Re: **Petition for Modification for Sutter Energy Center (97-AFC-2C)**

PETITION TO AMEND THE LICENSE FOR THE

SUTTER ENERGY CENTER

Amendment No. 6

FIGURE 1-2
Project Features
Sutter Energy Center

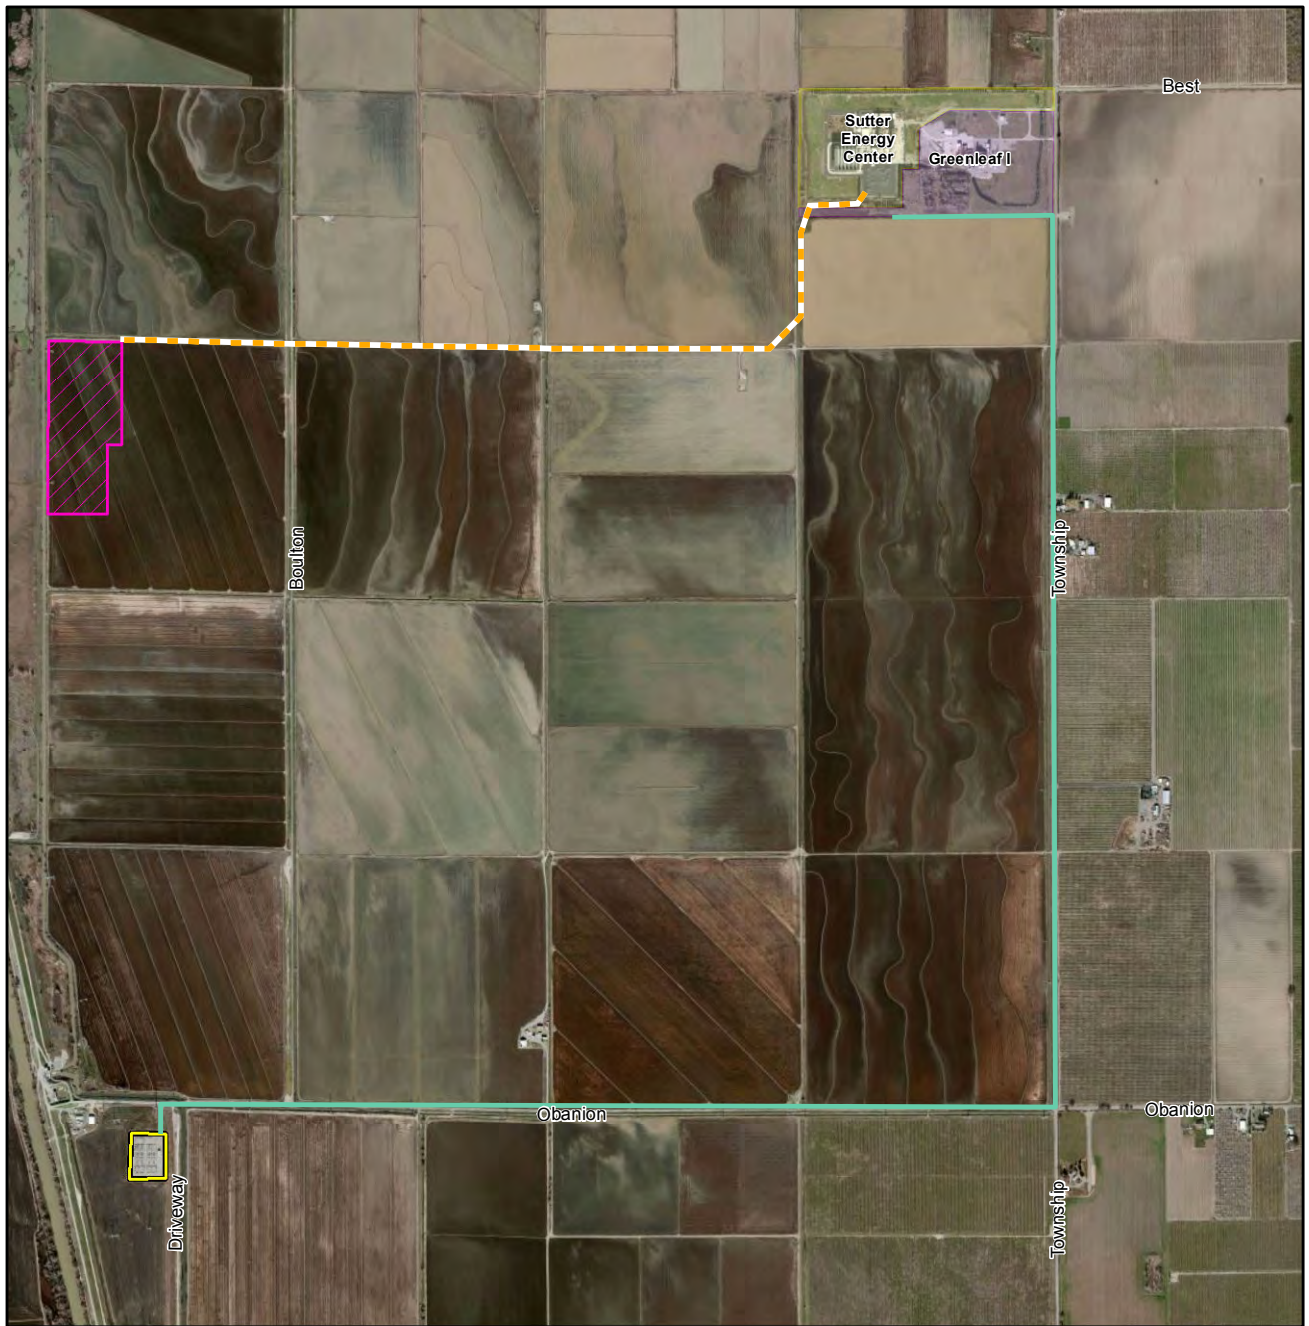
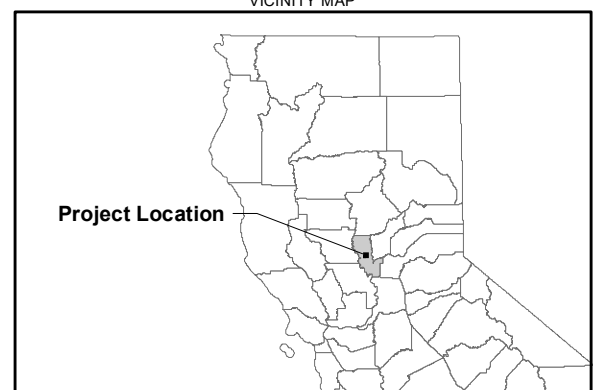
CCFC's existing generator tie-line connects SEC to Western's O'Banion Substation, which is located approximately 2.3 miles southwest of SEC (Figure 1-2). Because Western is no longer a California Independent System Operator (CAISO) participant, however, this interconnection no longer allows SEC direct access to a broad array of suitable power markets throughout California. For this reason, CCFC is proposing to construct a new, underground replacement generator tie-line and substation that would connect with PG&E's Table Mountain-to-Tesla 500 kV transmission line and would facilitate power marketing to the CAISO-controlled grid that serves much of California. The new generator tie-line would exit the SEC site at the existing switchyard, and then travel west, south, and west along agricultural roads that provide access to rice fields for approximately 1.71 miles to a new substation location adjacent to PG&E's 500 kV Table Mountain-to-Tesla transmission line. PG&E will construct the new substation on a 25- to 35-acre site in the approximate location shown in Figure 1-2 that is currently occupied by a rice field and duck hunting blinds, and CCFC will install a bank of step-up transformers on a 3- to 5-acre site adjacent to the new PG&E substation to transform power from 230 kV to 500 kV for export on the PG&E line. The first point of interconnection with the CAISO-controlled grid will be the PG&E bus on the high side of the CCFC transformers. The new substation will be designed, constructed, owned, and operated by PG&E under

CCFC will install a new underground generator tie-line and step-up transformers to interconnect with a new substation that PG&E will design, construct, and own in the approximate location shown in Figure 1-2. The generator tie-line and substation will connect SEC with the CAISO system at PG&E’s Table Mountain-to-Tesla 500 kV line. The new generator tie-line will be approximately 1.71 miles long and will be installed underground. It will extend from the existing 230 kV switchyard located on the SEC facility site south for approximately 170 feet to the southeast, crossing a drainage canal to the southern part of the CCFC parcel. The route then runs for approximately 475 feet to the west before turning south to follow an agricultural road for approximately 1,200 feet, where it then runs on a northeast-to-southwest diagonal for approximately 500 feet through a rice field, crossing drainage and irrigation canals. The route then turns west onto a rice field farm access road and extends to the west on this road for 6,700 feet to a point where it enters the northeast corner of the substation property, crossing two additional irrigation canals and Boulton Road.
